SUNDRY NOTICES AND REPORTS ON WELLS

Energen Resources would like to request the following changes to the drilling plans for the Chacon Jicarilla #602H.

Drilling Plan
Energen Resources Corporation
 Revised 5/11/15

Chacon Jicarilla #602H

Plan #2

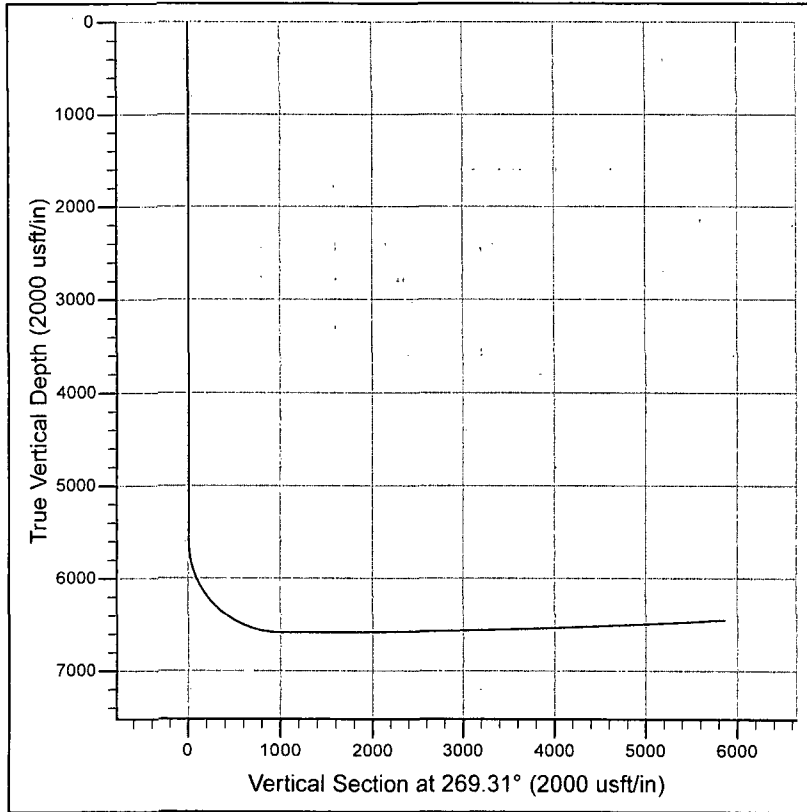
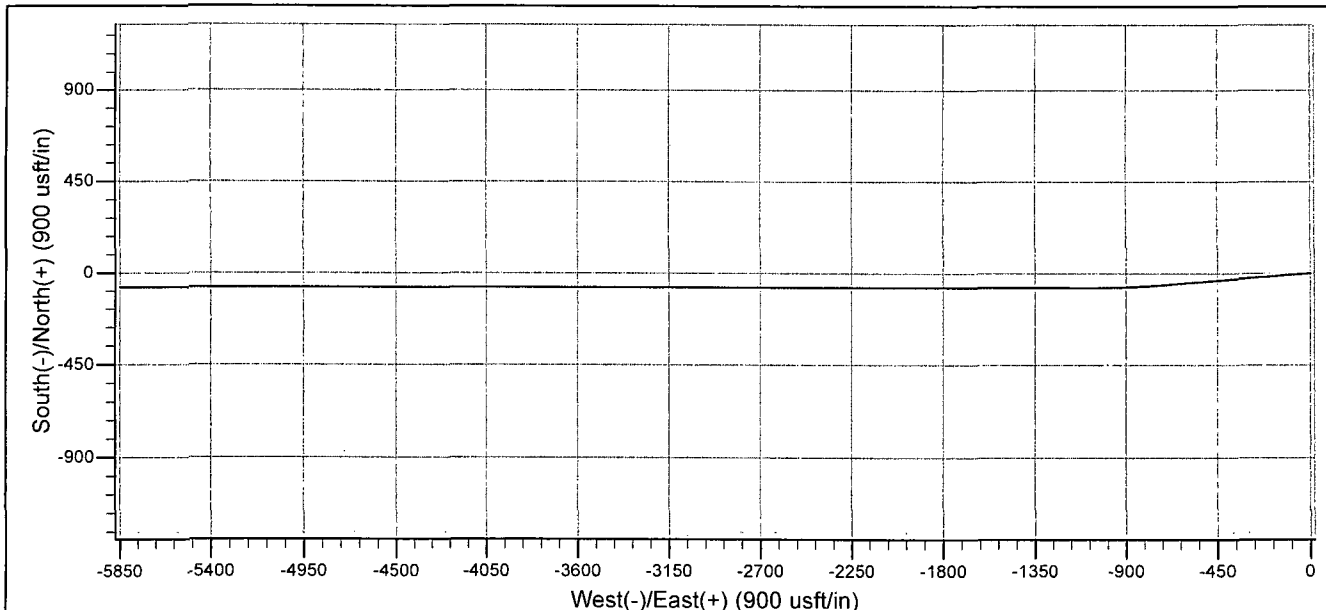
Change Surface csg: From 13-3/8", H-40, 48# STC to 9-5/8", J-55, 36# LTC
Change Intermediate csg: From 9-5/8", L-80, 43.5# LTC to 7", L-80, 26#, DQX
Omit Tie-Back
Change Production csg: From 4-1/2", P-110, 11.6#, LTC to 4-1/2", P-110, 11.6# DQX

Attached are the new drilling plans depicting the changes along with the directional design.
